**From:** [Billings, Bradford, EMNRD](#)  
**To:** [Yu, Olivia, EMNRD](#)  
**Subject:** FW: EMSU B  
**Date:** Friday, March 2, 2018 8:47:51 AM  
**Attachments:** Schematic- Drawing of Proposed Recovery Station.pdf

# EMSU B Produced Water Recovery Station

**XTO Energy, Inc.**  
EMSU B Produced Water Release  
Unit P (SE 1/4, SE 1/4)  
Sec. 14, T. 20 S., R. 36 E.  
Lea County, New Mexico  
32° 34' 02.07"N  
103° 19' 13.29"W

Schematic - Drawing of Proposed Recovery Station

**Diagram for Spill Containment (Top View)**  
**EMSU B Produced Water Recovery Station**

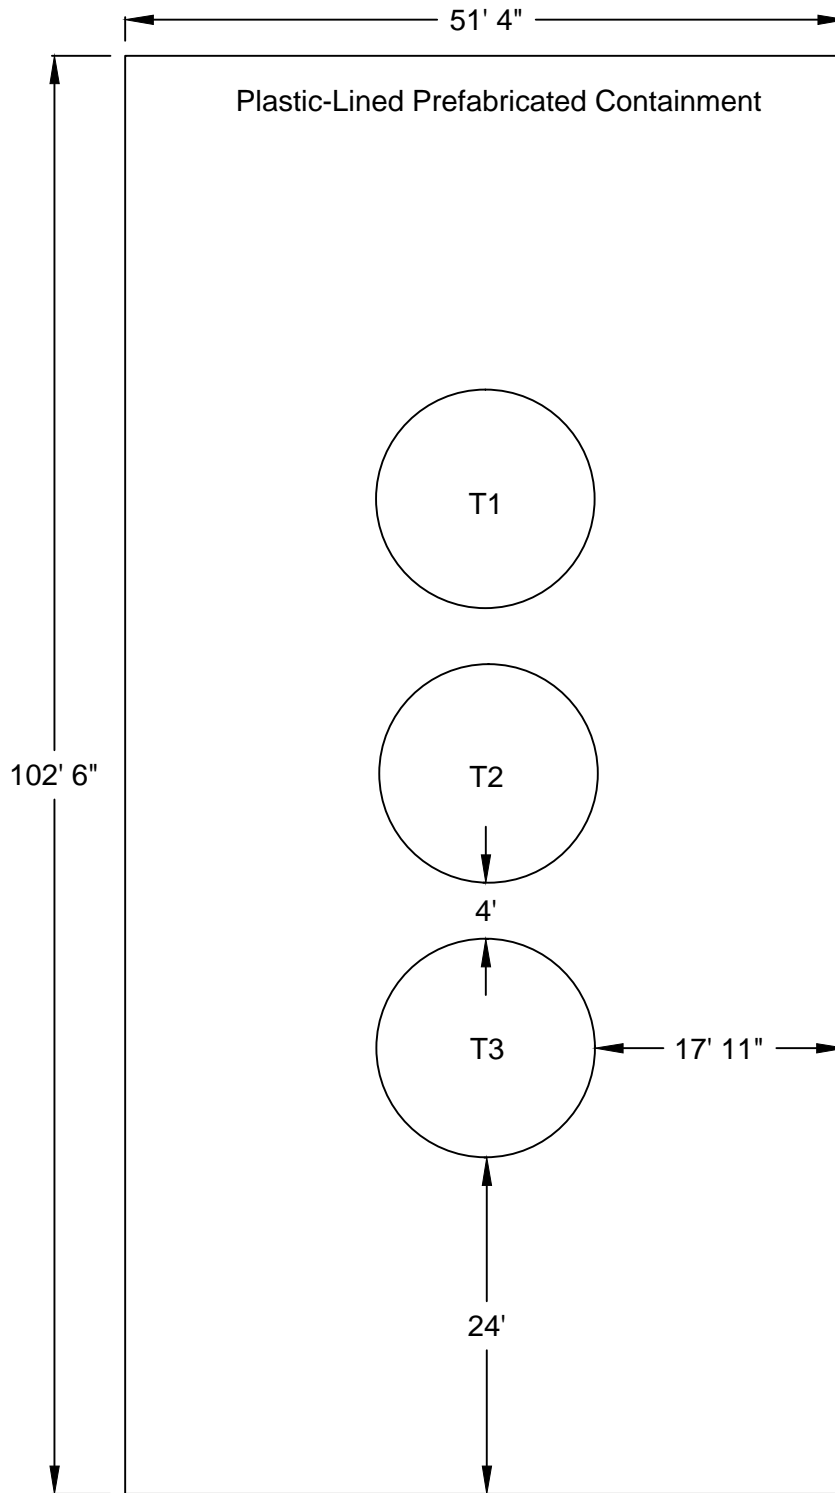
Also, and it may already be indicated in your submittal, but I will reiterate the need for appropriate berm control about the storage tanks for water collection prior to piping water to disposal. It is 1.3 times the total possible release volume. It would be per tank if not connected, but if possibility exists in plumbing that if one leaks all leak, then it would be total volume. Just as reminder.

Bradford,  
Per your email below I have corrected the drawing to show the three (3) additional recovery wells. Per your email below I've requested Robert Bassom, engineering, to review the containment design to meet the requirement to hold the total volume assuming the three tanks are interconnected. I will forward the drawings to you once engineering gets back to me. Also, I will forward the email from BLM approving installing the remediation system. I have arranged for a monitor (archeologist) to be on location while the recovery trench is installed as requested by BLM. The XTO representative for submitting the approval to is as follows:

Containment Length : 102' 6"  
Containment Width : 51' 4"  
Containment Height : 2' 6"  
Containment Volume : 1,890 bbl (3 Tanks + 25 Yr 24 Hr Rainfall)

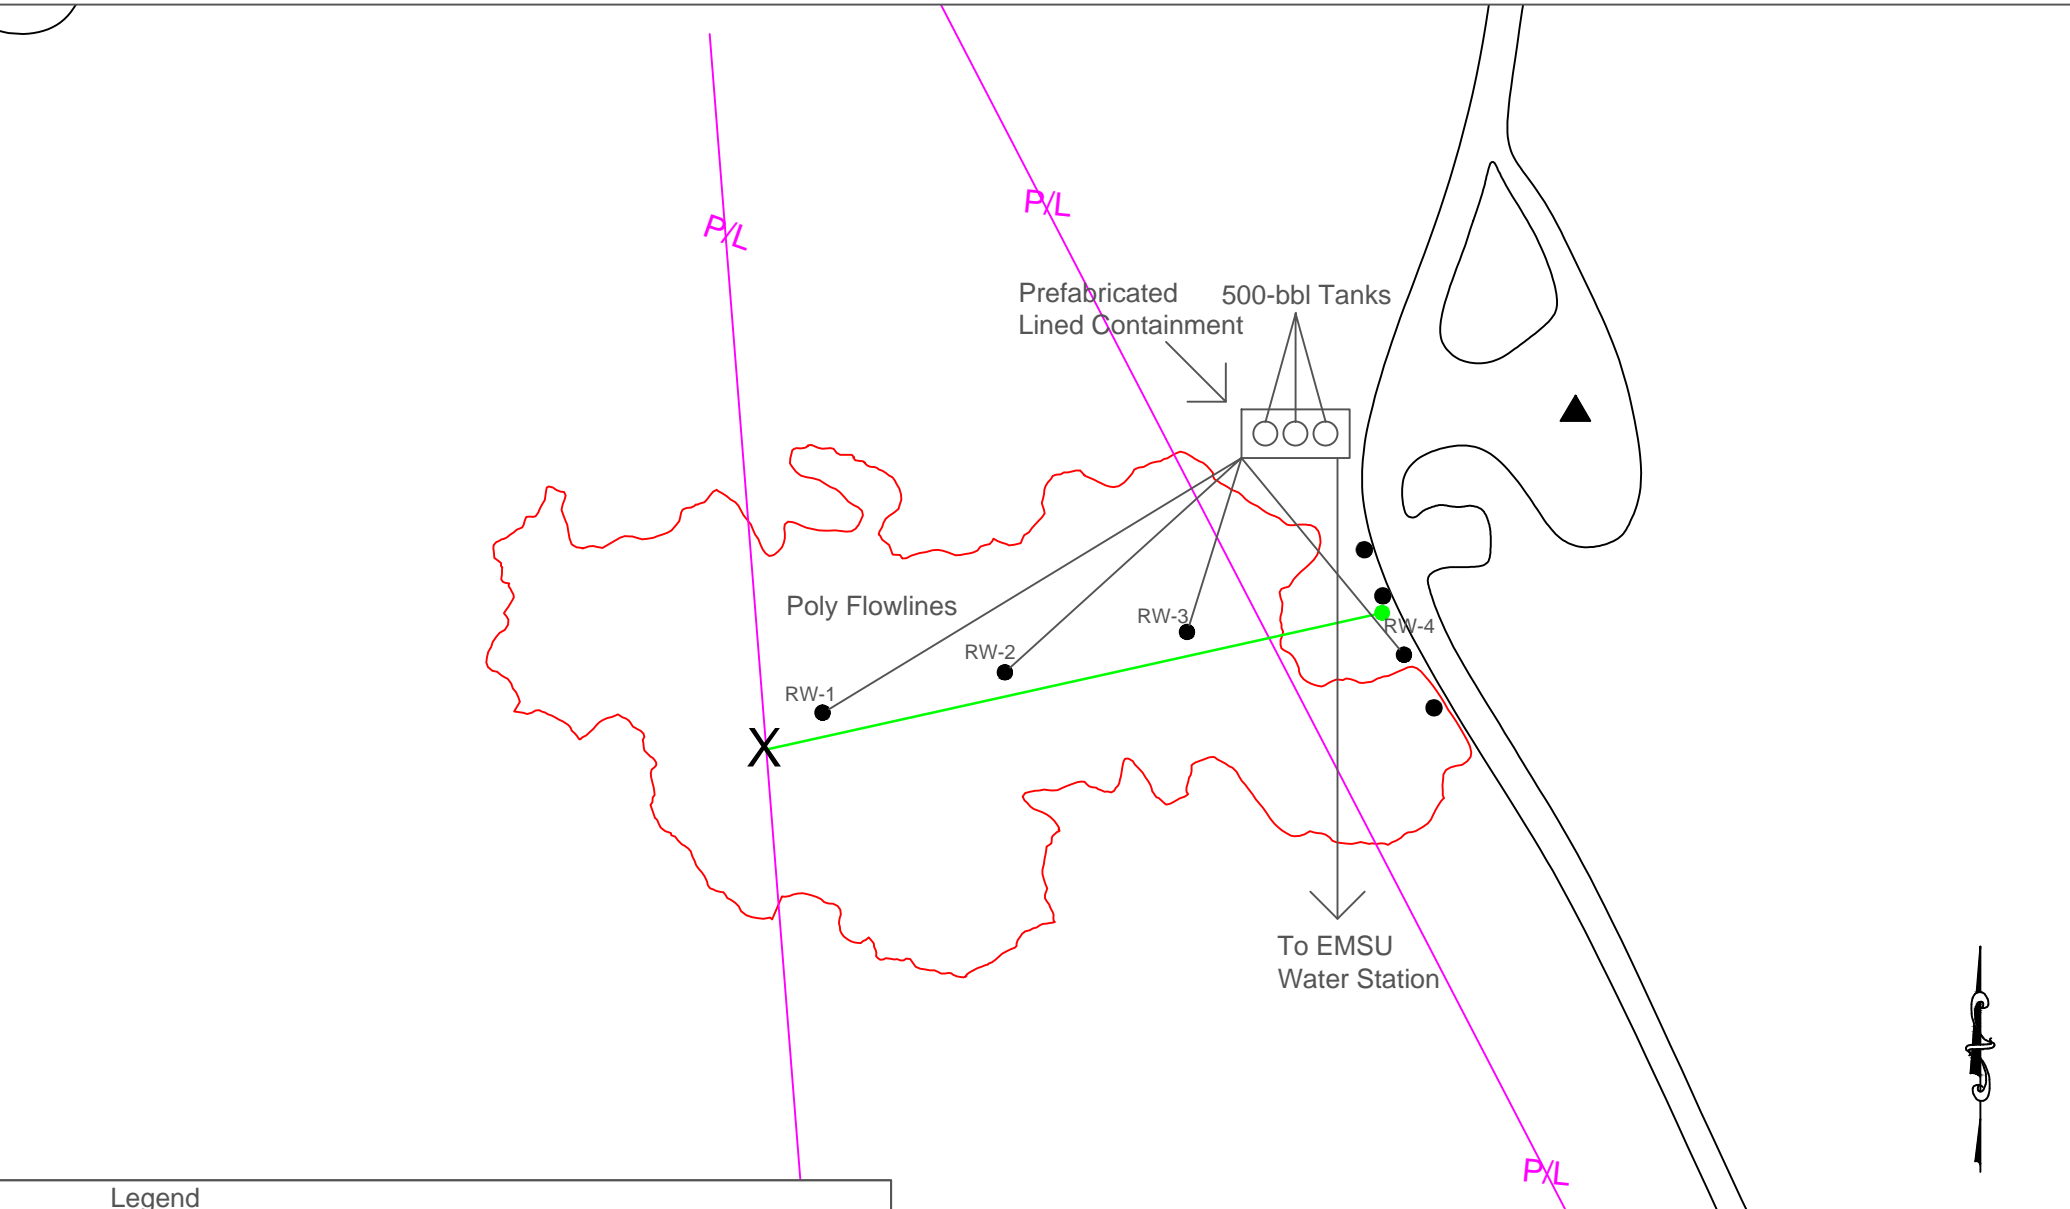
So am getting ready to send out an approval for the trench remedial efforts for this site. Will include condition to place the additional recovery wells on the down slope side  
As we discussed. I believe it was three of them?

Bradford,  
Please find the revised drawing attached for changing the three (3) recovery wells from alternate to permanent. I will forward the revised containment drawing to show containment for the total volume of the tanks. Please contact me if you have questions.  
Mark

- Proposed Recovery Well Location
